STAFF REPORT

Subject: Dierking Single Family Dwelling Addition, 220 North Lake Drive, Washoe County, Nevada; Assessor's Parcel No: 123-161-01; TRPA File No: ERSP2018-0454

Proposed Action:
Hearings Officer action on the proposed project and related findings based on this staff summary and the draft permit (Attachment A).

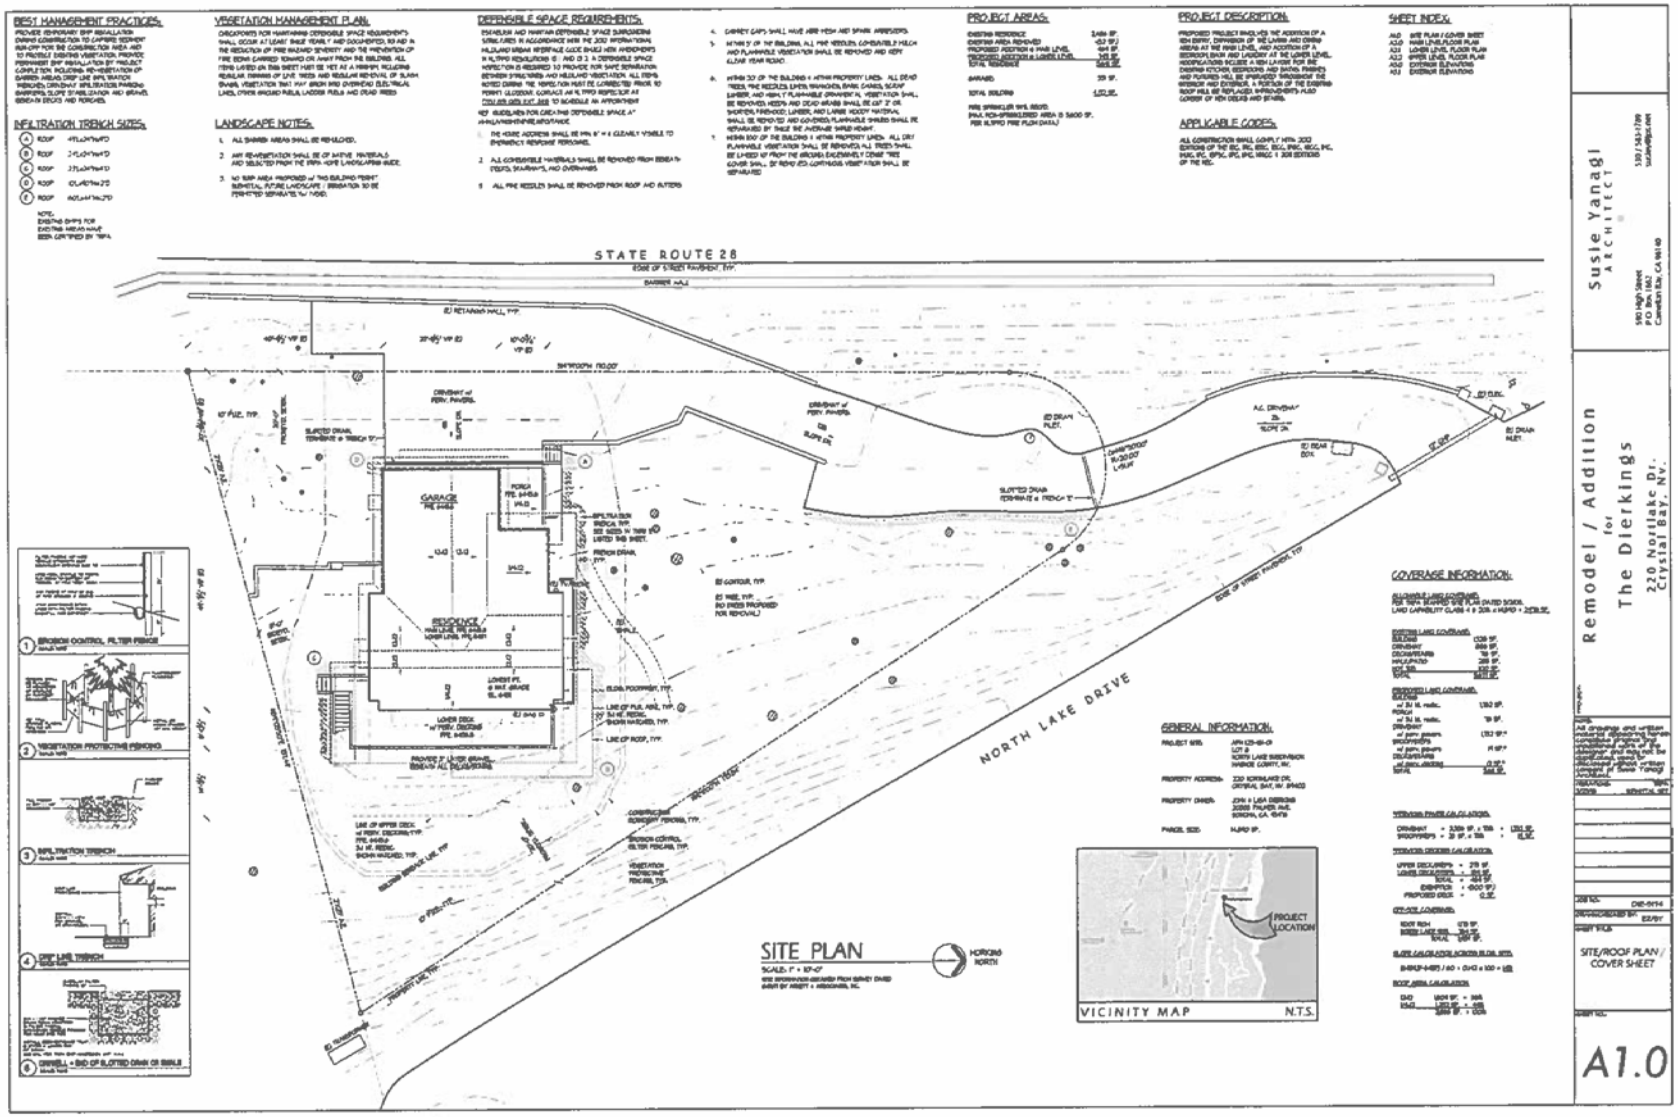
A. The site plan shall be revised as follows:

(1) The location of all proposed staging areas shall be indicated on the final site plan. Staging areas shall conform to the requirements of Section 36.12 and other applicable sections of the TRPA Code.

(2) The unauthorized retaining wall and stone patio on the south side of the house shall be illustrated on the final plans. In addition, a note shall be added to the final plans that states that the patio shall be removed and the affected areas shall be revegetated.

B. The site plan shall be revised to include the location of the buried drainpipe connected to the existing "drain inlet" (located midway along the driveway and illustrated on Sheet A1.0), and storm water infiltration device(s) for this drainage feature.
